Department of Energy
Albuquerque Operations Office
P.O. Box 5400
Albuquerque, New Mexico 87115

By your letter dated November 17, 1987, the Nuclear Regulatory Commission (NRC) submitted comments on the Remedial Action Plan and Final Design for the Tuba City, Arizona, uranium mill tailings site. Enclosed for your use and information are responses to those comments. These responses should adequately address NRC's concerns; we are, therefore, requesting NRC concurrence with the proposed remedial action by January 29, 1987.

UMTRA DOCUMENT REVIEW FORM

Site: Tuba
Document: RAP and Final Design, Date: November 17, 1987
Commentor: NRC

UU TEST RESULTS ON GREASEWOOD LAKE MATERIAL

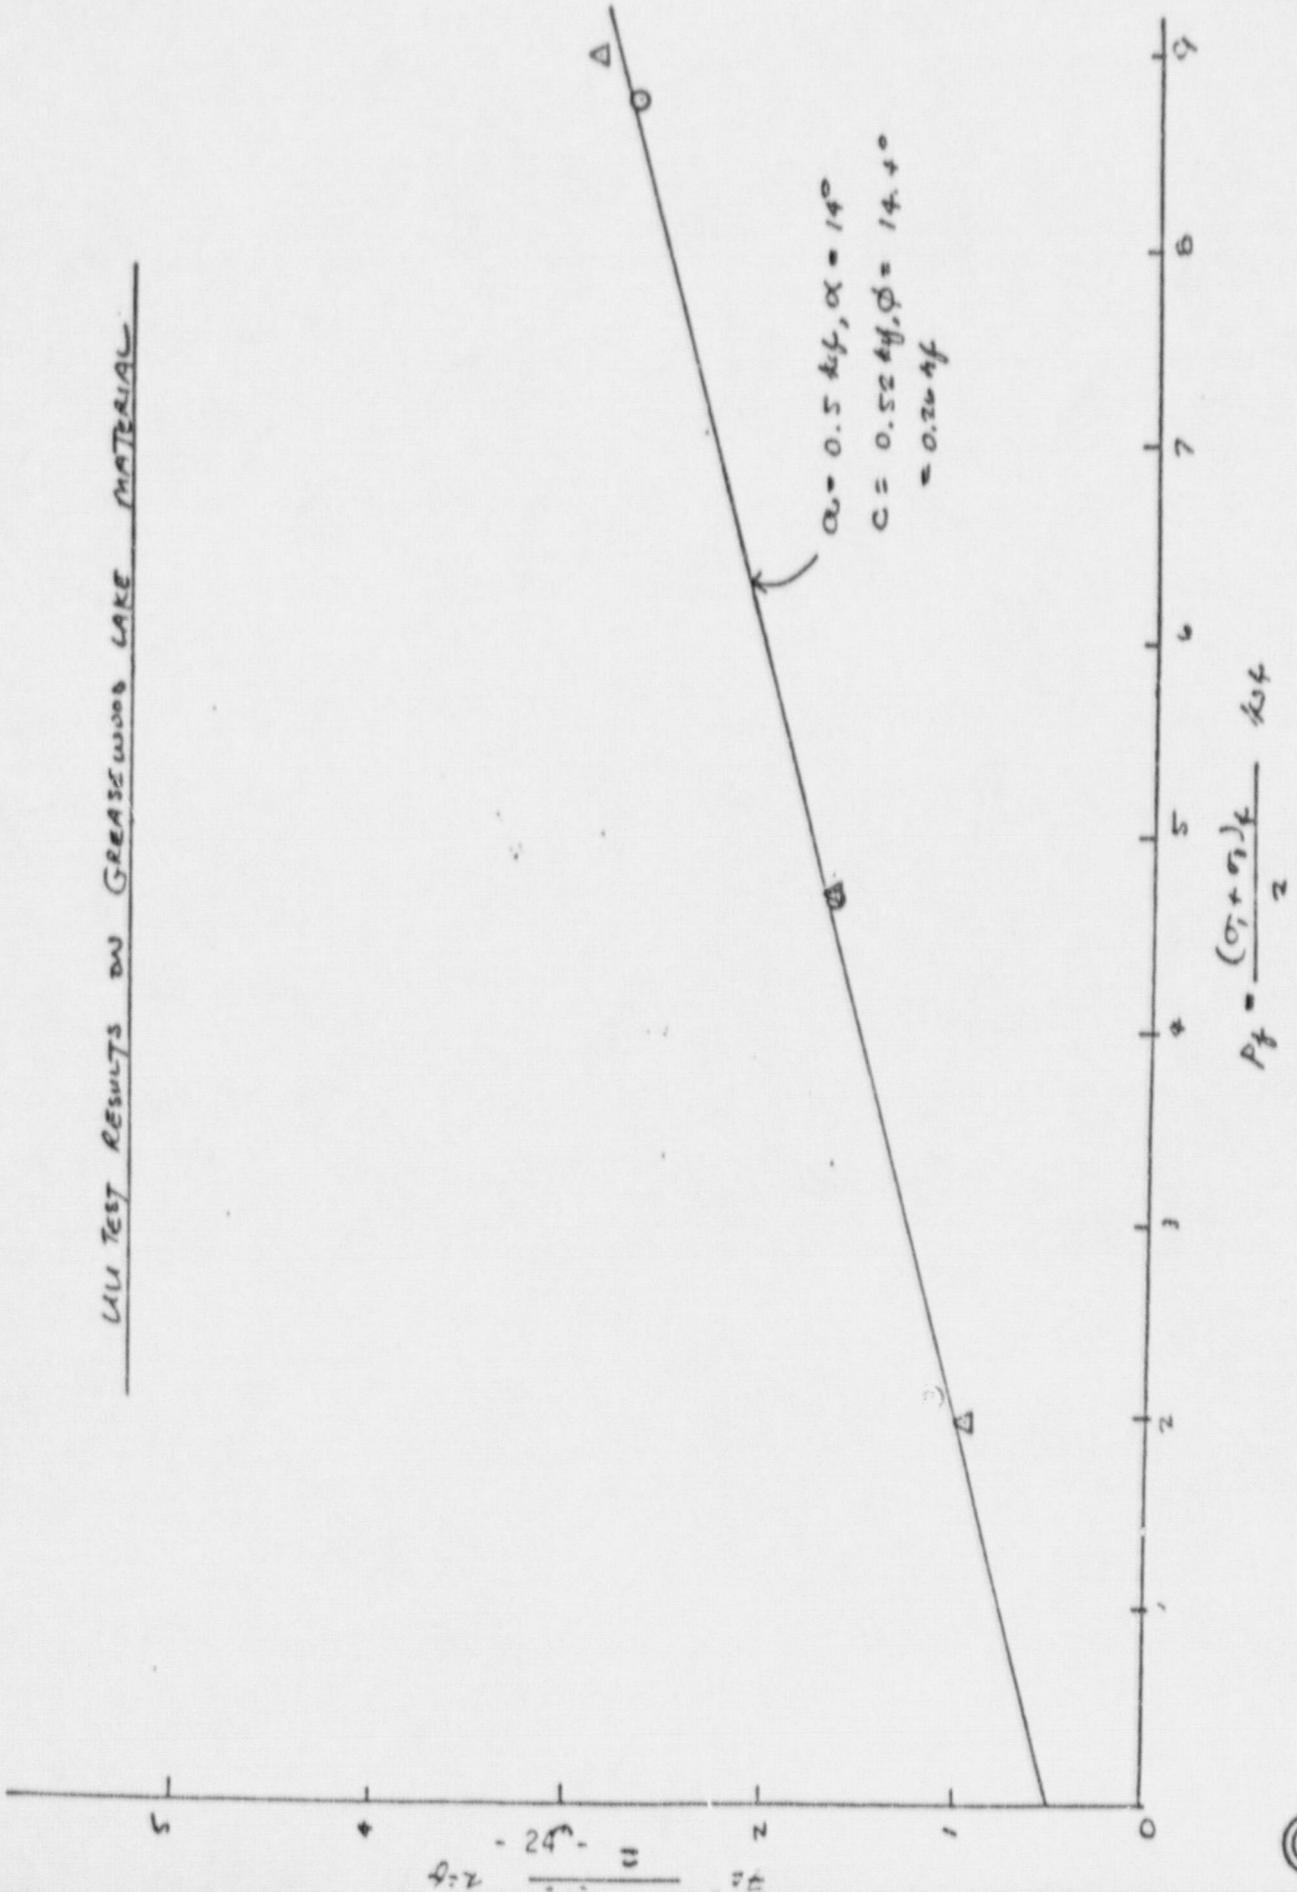
1. The design values presented in Appendix D of the RAP are not in agreement with the parameters used in the stability models. Specifically, please clarify why the undrained shear strength cohesion value of the radon barrier material was increased to 520 psf from 260 psf.
2. It is difficult to evaluate the results of the stability model as it appears that only selective results were submitted. Please submit the entire output for each computer run or as a minimum, the input data summary and minimum circle results for each separate run.

"Short-term" shear strength parameters for the radon barrier are defined by two UU (or "Q") tests performed on samples compacted to 95% of the Standard Proctor maximum dry density. Data for these tests and interpretation of the results is presented on pp. 92-93 in the MKE Calc. No. 18-839-01-00 (Tuba City Calculation Vol. I). See attached pages. The interpretation of results is presented with the reasonable and standard approach of a best-fit line through the p'_f - q_f data points. We believe that the design parameters are appropriate for the following reasons:

1. The "UU" cohesion of 520 psf is based on a best-fit curve through the data points. The TAC's value for "UU" cohesion of 260 psf is considered very conservative.

The UU test results are shown on pp. 92-93. From these tests, $c = 0.26 \text{ TSE}$ and $\phi = 14.4^\circ$.
